REQUEST FOR INFORMATION	DATE: March 31, 2017	NO.: RFI-505
--------------------------------	-----------------------------	---------------------

Project Name: 15051-Webster University Interdisciplinary Science Building	Project No.: 15051
---	--------------------

Subject: Additional angle needed for masonry

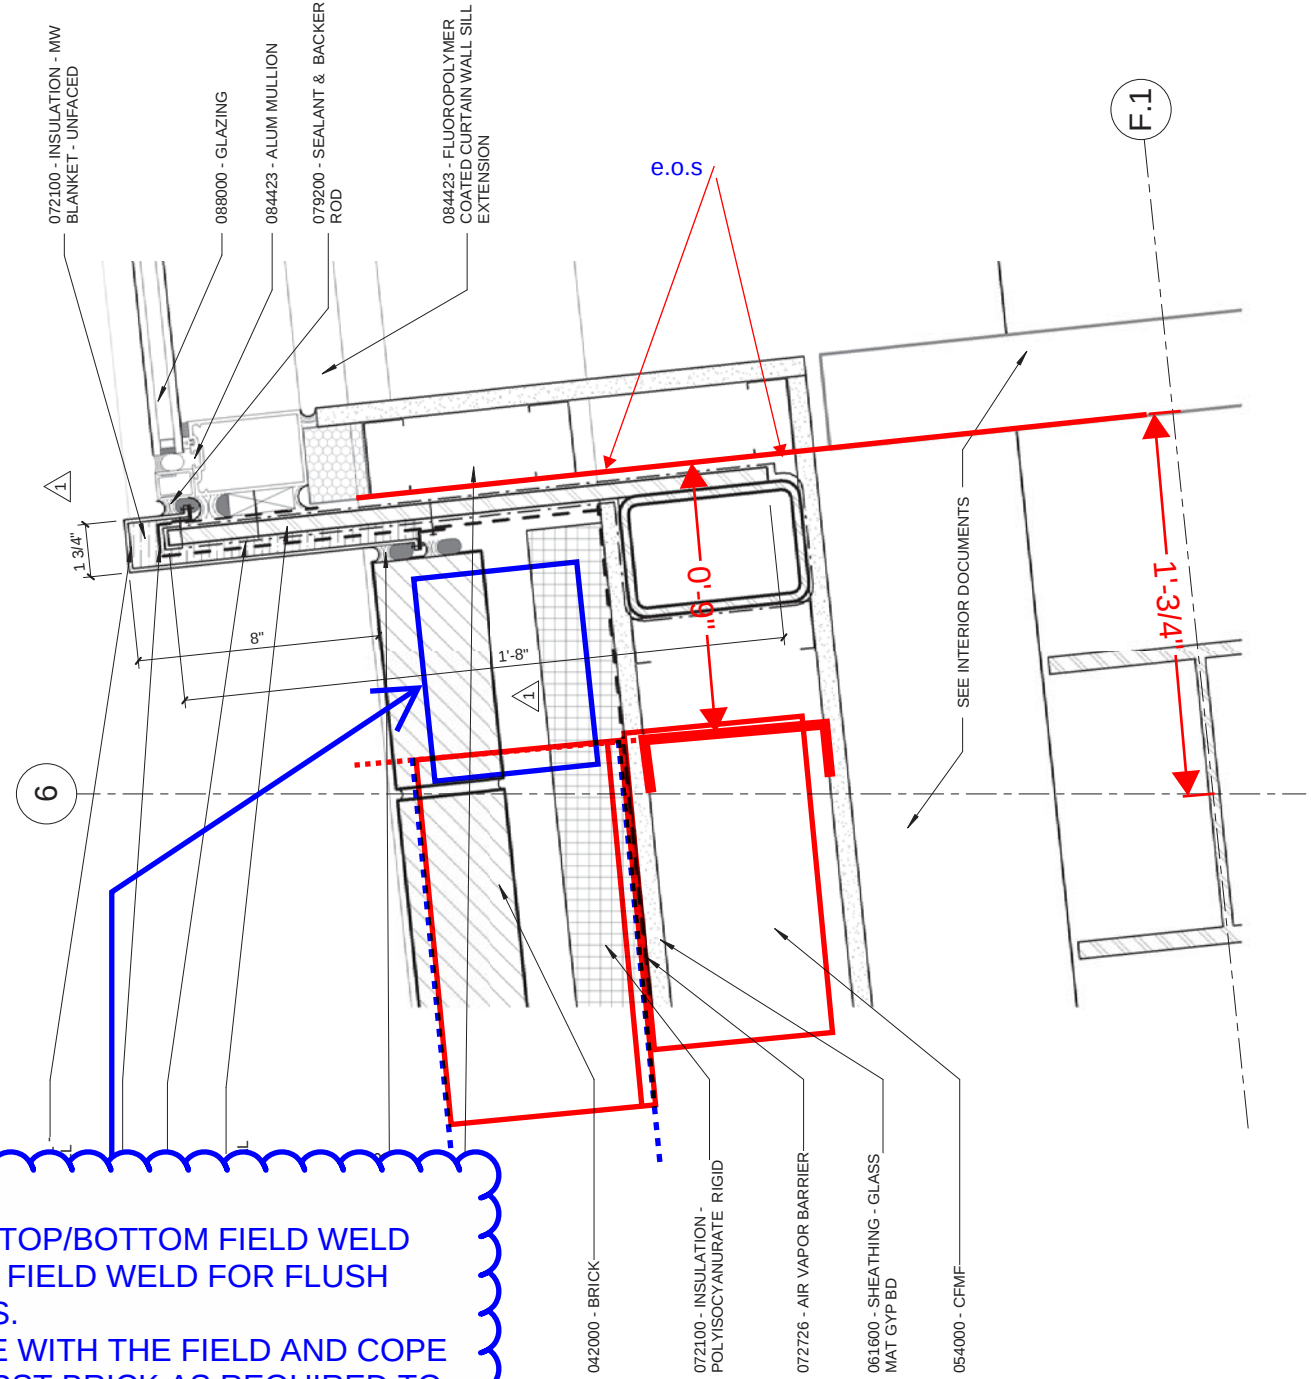
Structural steel was fabricated and installed per 13/S303 which has a 9" gap between the horizontal and vertical supports (see attached photo). This will not provide sufficient support to install the masonry per 1/A423. Paric proposes to extend the horizontal support to the vertical support.

Response: A HORIZONTAL CLOSURE PIECE IS ACCEPTABLE. 1/4" IS SUFFICIENT WITH A 1" OVERLAP ON THE HORIZ LEG OF THE EXISTING ANGLE. BOTTOM OF FIRST BRICK WILL NEED TO BE COPED IN ORDER FOR THE HORIZ JOINT TO REMAIN A CONSISTENT WIDTH. FIELD WELD T&B. OPTION: PARTIAL BEVEL AND BUTT WELD TOP FOR FLUSH SURFACE AND NO ADJUSTMENT TO BOTTOM OF FIRST BRICK.
